ORDINANCE NO. 2018-01-___

AN ORDINANCE OF THE CITY COUNCIL OF THE CITY OF MCKINNEY, TEXAS, AMENDING THE CODE OF ORDINANCES OF THE CITY OF MCKINNEY, TEXAS, THROUGH THE AMENDMENT OF CHAPTER 122, "CONSTRUCTION REGULATIONS," BY AMENDING ARTICLE II, "BUILDING CODES," BY AMENDING SECTION 122-25, "*INTERNATIONAL BUILDING CODE AND INTERNATIONAL RESIDENTIAL CODE ADOPTED*," SECTION 122-26, "AMENDMENTS TO BUILDING AND RESIDENTIAL CODES," SECTION 122-30, "*INTERNATIONAL MECHANICAL CODE ADOPTED; AMENDMENTS*," SECTION 122-31, "*INTERNATIONAL PLUMBING CODE ADOPTED*," SECTION 122-32, "AMENDMENTS TO PLUMBING CODE," SECTION 122-35, "*INTERNATIONAL ENERGY CONSERVATION CODE ADOPTED*," SECTION 122-36, "AMENDMENTS TO ENERGY CONSERVATION CODE," AND SECTION 122-38, "*INTERNATIONAL PROPERTY MAINTENANCE CODE ADOPTED*," AND ADDING A NEW SECTION 122-34, ENTITLED "*INTERNATIONAL FUEL GAS CODE ADOPTED*," AND THROUGH THE AMENDMENT OF CHAPTER 126, "HOUSING," BY AMENDING ARTICLE II, "SUBSTANDARD STRUCTURES," BY AMENDING SECTION 126-40, "*INTERNATIONAL PROPERTY MAINTENANCE CODE ADOPTED*," FOR THE PURPOSE OF ADOPTING THE 2015 EDITIONS OF SUCH INTERNATIONAL CODES; THROUGH THE AMENDMENT OF CHAPTER 122, "CONSTRUCTION

****Figure R602.6.1; delete the figure and insert the following figure:**

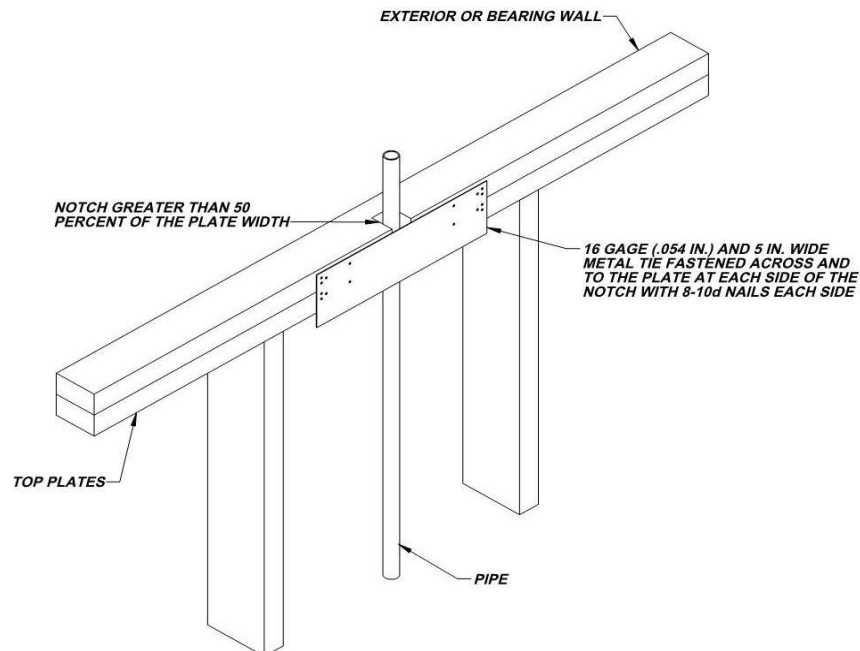
R602.6.1 Drilling and notching of top plate. When piping or ductwork is placed in or partly in an exterior wall or interior load-bearing wall, necessitating cutting, drilling or notching of the top plate by more than 50 percent of its width, a galvanized metal tie not less than 0.054 inch thick (1.37 mm) (16 Ga) and ~~4 ½ inches (38) mm~~ 5 inches (127 mm) wide shall be fastened across and to the plate at each side of the opening with not less than eight 10d (0.148 inch diameter) having a minimum length of 1 ½ inches (38 mm) at each side or equivalent. Fasteners will be offset to prevent splitting of the top plate material. The metal tie must extend a minimum of 6 inches past the opening. See figure R602.6.1. {remainder unchanged}

(Amendment to 2012 IRC carried forward to 2015 IRC also provides additional assurance of maintaining the integrity of the framing by spreading the nailing pattern.)
